From:	Danny Mapili - WPD-C
To:	Joshua Hill
Cc:	Terry Lamb Sr.; Todd Williams; Edwin Lopacki - WPIB
Subject:	Fwd: FERC Swing: Status of Design Review
Date:	Tuesday, July 19, 2016 3:00:59 PM
Attachments:	image001.png OPDO Project Comment Sheet - FERC 100% CD"s- OTJ Response.pdf REVISED A702 - ELEVATIONS.pdf REVISED A701 - ELEVATIONS.pdf REVISED A302 - POWER AND SIGNAL PLAN 30x42.pdf

I would like to check the status of the Design Review for the 100%CD's FERC Swing.

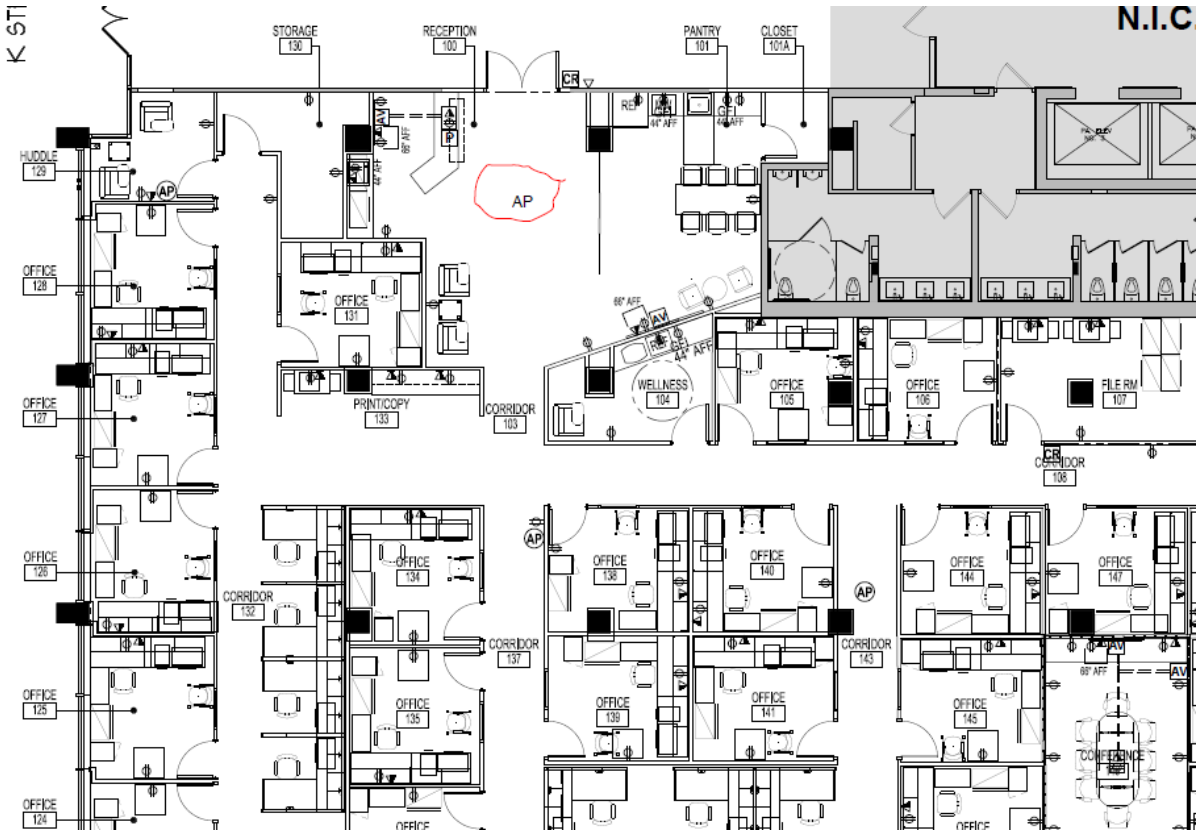
> Danny,
>
> Below are our comments:
>
> On A301, we may need an additional wireless access point located in the vicinity of the entrance to the suite (see drawing below).
>
> Also, I do not see where the low-voltage cabling is included anywhere, either in the drawings or specifications. We had discussed this being included in the construction work.
